REGIONAL REVIEW FINDING

ARC REVIEW CODE: R809242

Name of Proposal: Big Creek

Review Type: Development of Regional Impact

BIG CREEK LAND PLAN
Lake Lanier Islands Resort
Buford, Georgia

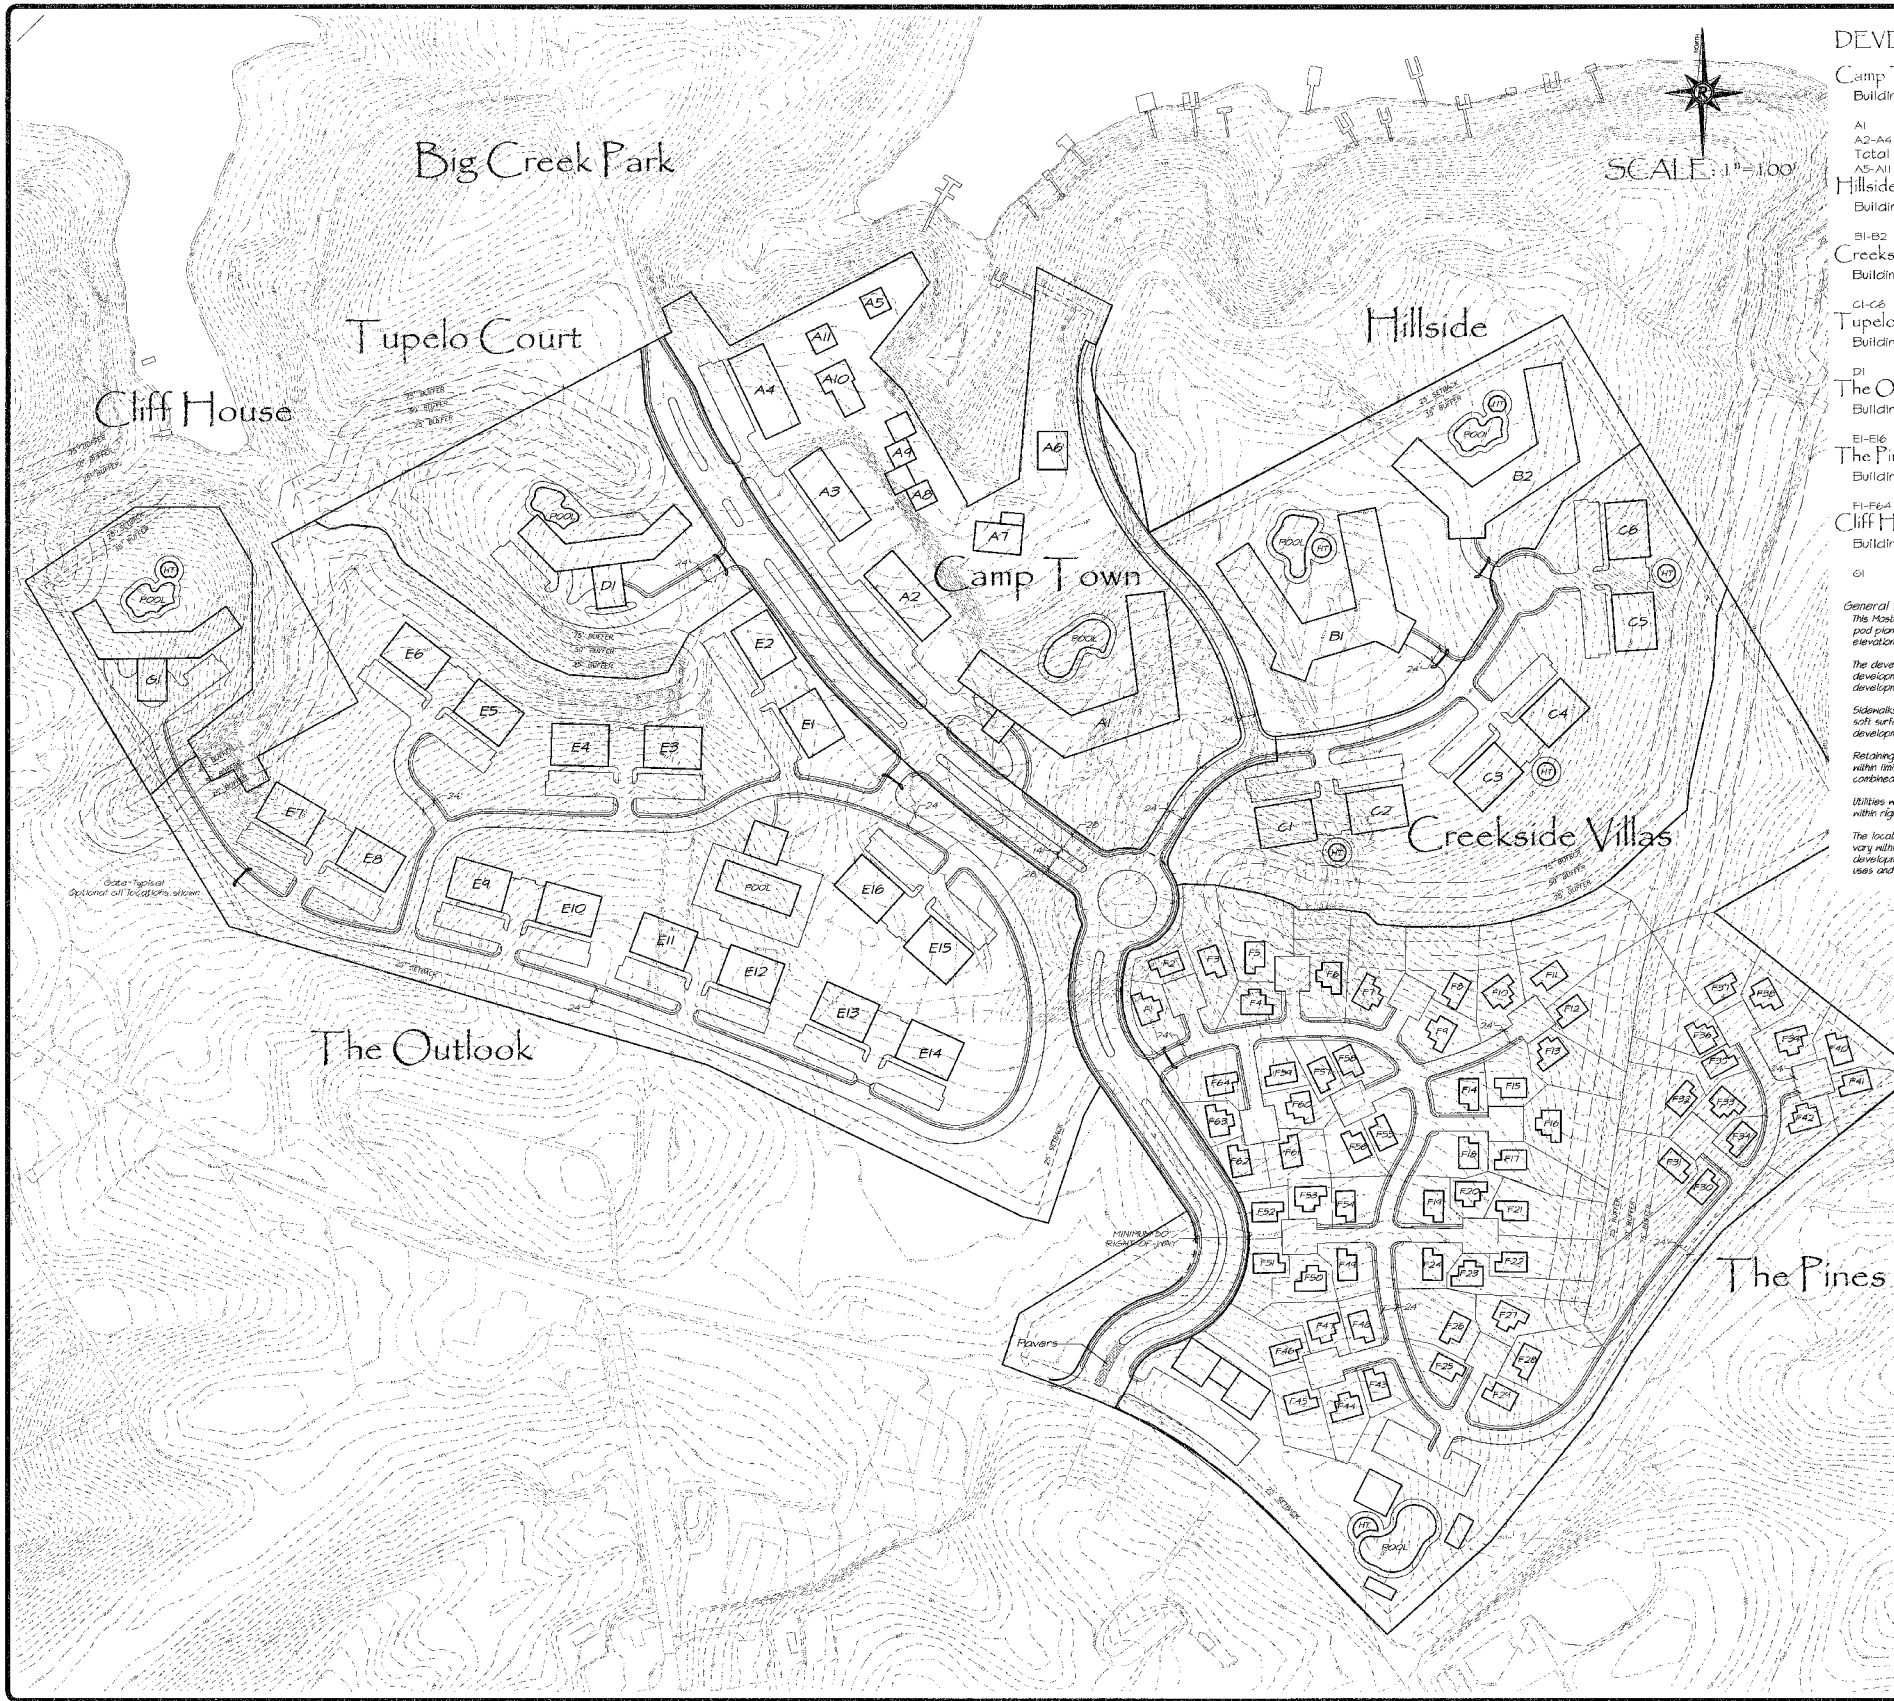
No streams are shown on the USGS coverage for the project area. However, the submitted plans show a stream and its tributary along the eastern edge of the property as well as a stream on the western end of the site. For both streams, the plans show the 25-foot state sediment and erosion control buffer as well as the 50-foot buffer and additional 25-foot setback required in the City of Buford's stream buffer ordinance. No intrusions are shown within the buffers. Any other streams on the property may be subject to City buffer ordinance. Any other state waters on the property will be subject to the state erosion and sedimentation control buffer.

development could provide a compatibility concern with the existing development pattern. In addition, it is difficult to ascertain on the concept plan the amount of buffering of adjacent residential property.
